HT802 Firmware Release Note

FIRMWARE VERSION 1.0.3.2

HT802

PASSWORD CHANGE CONFIRMATION

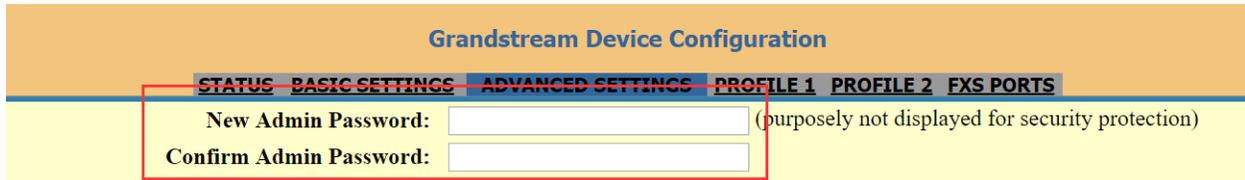
- Added a re-enter box to confirm change user and admin password on web GUI to avoid typo or mistakes. [PASSWORD CHANGE CONFIRMATION]

When change admin password, re-enter the changed password to confirm the new password is correctly entered.
